**PLANNING COMMISSION MEETING STAFF REPORT**

**DATE OF MEETING:** September 14, 2021  
**NAME OF PROJECT:** Mill Canyon Farms  
**NAME OF APPLICANT:** Berg Engineering for Jordan and Lynne Law  
**OWNER OF RECORD:** Jordan and Lynne Law  
**AGENDA ITEM:** Preliminary Approval  
**LOCATION OF ITEM:** 250 West 970 South  
**ZONING DESIGNATION:** R-1-22

**Subject: Mill Canyon Farms – Preliminary Review**

LAW  
**MILL CANYON FARMS**  
 PRELIMINARY UTILITY PLAN

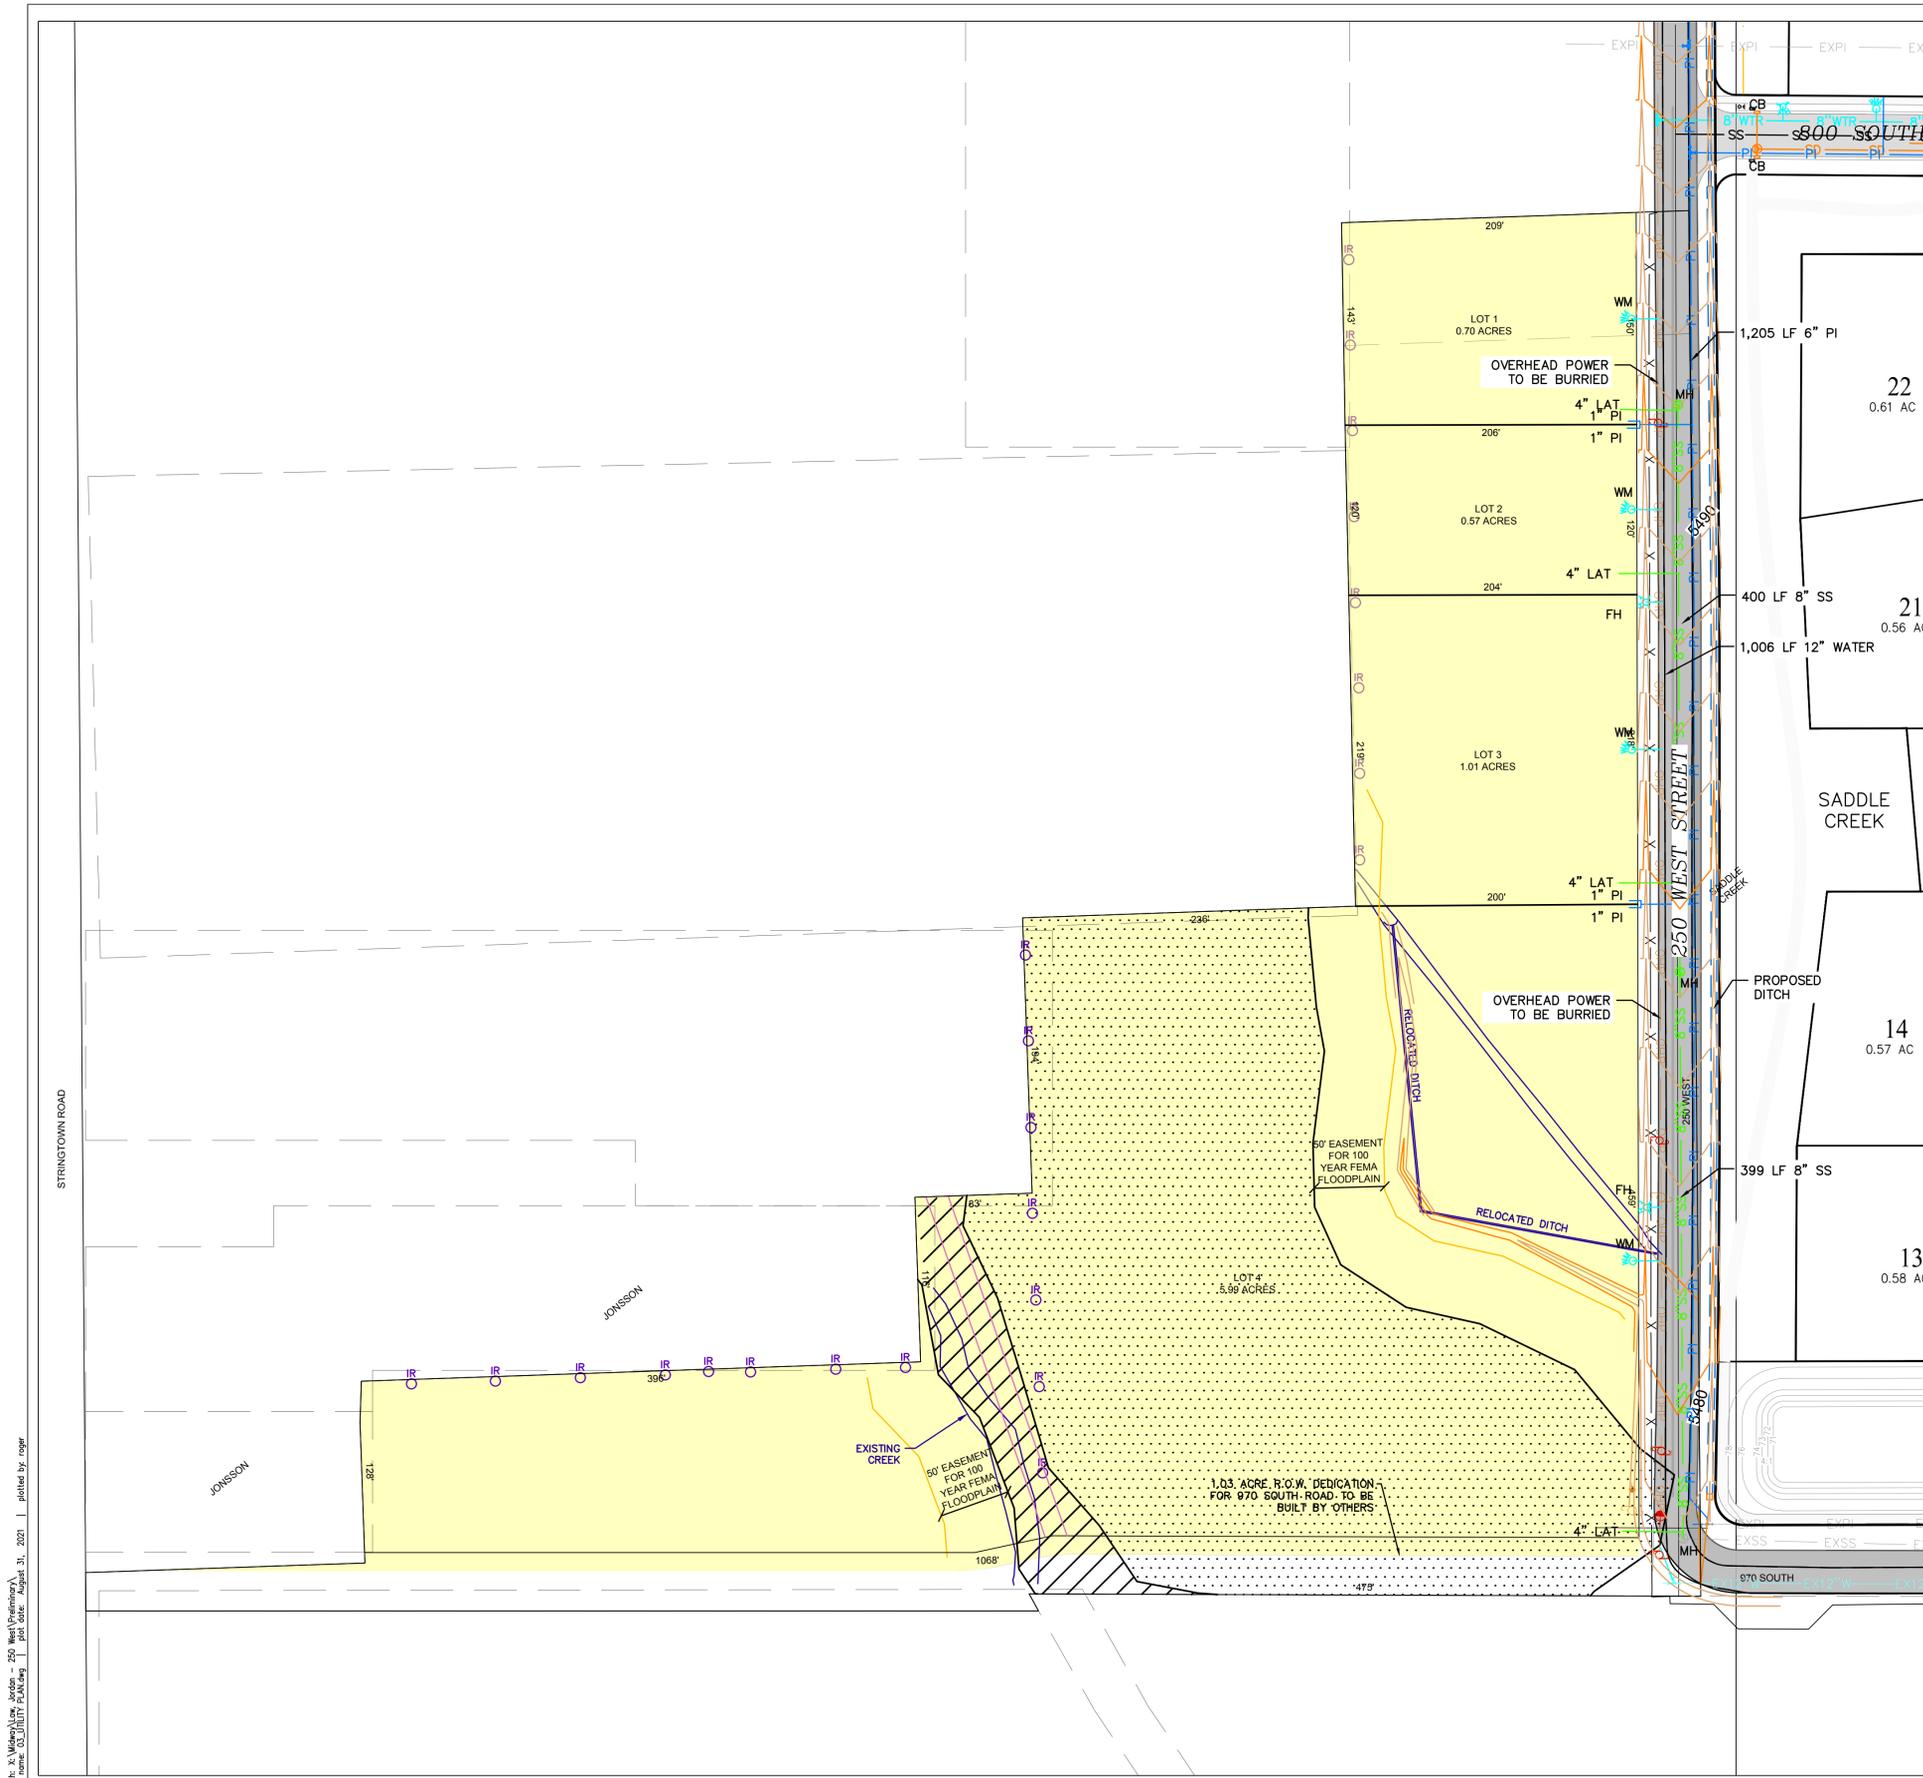
- The west side of 250 west will be rebuilt and widened to a half width of 15 to match the east side done as part of Saddle Creek Subdivision.
- The development will dedicate R.O.W for a future road to extend 970 South from 250 West to Stringtown Road.

- No trails are shown to be constructed within the development, the development will need to dedicate 15' R.O.W for a future trail along future 970 South and will need to dedicate 20' R.O.W for a future trail along Snake Creek.

- The proposed swale along the west side of 250 West will accommodate any storm drainage from the widening of 250 West and this development.

- The proposed lot 4 in the subdivision is within a designated FEMA flood plain. A 50' setbacks shall be maintained around all FEMA flood Zones.
